## LAUREATE PARK NEIGHBORHOOD CENTER PHASE 3

## SUMMARY

# MASTER PLAN ANALYSIS

# PROPOSED SITE PLAN

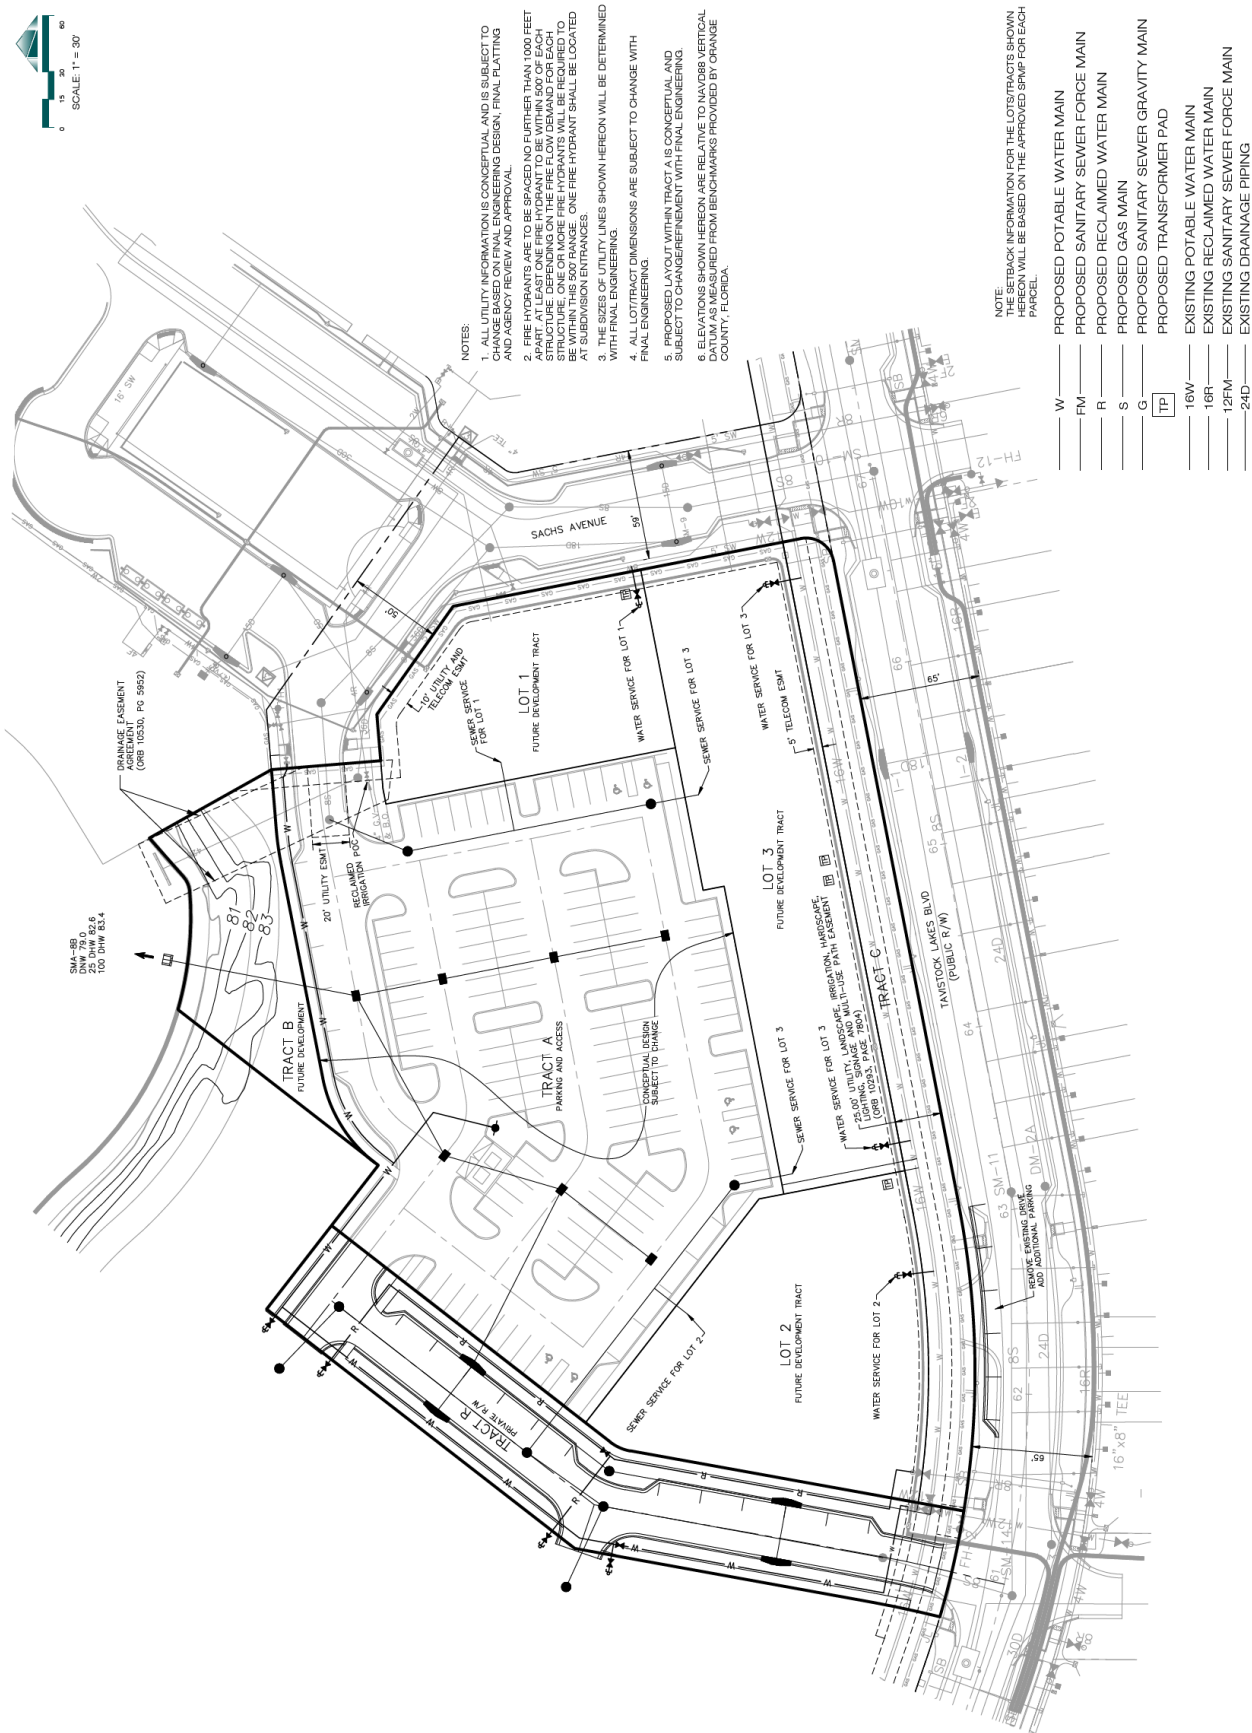
The proposed additional on street parking on Tavistock Lakes Blvd may not meet FDOT sight distance requirements for on street parking due to the geometry of the roadway. These spaces will be out of the sight distance requirements on construction plans submitted for permitting.

Remove the existing pedestrian crossing east of the Tavistock Lakes Blvd driveway, with the additional vehicles due to the activation of this site; the mid-block crossing is not safe.

Provide a marked crossing and ADA ramps for east/west travel across Tract R, the extension of Walcott Ave.

The future buildings on Lots 1, 2 & 3 should be designed to be clear of the 5' & 10' Utility and Telecom Easement, and avoid any encroachment in the Drainage Easement to the north.
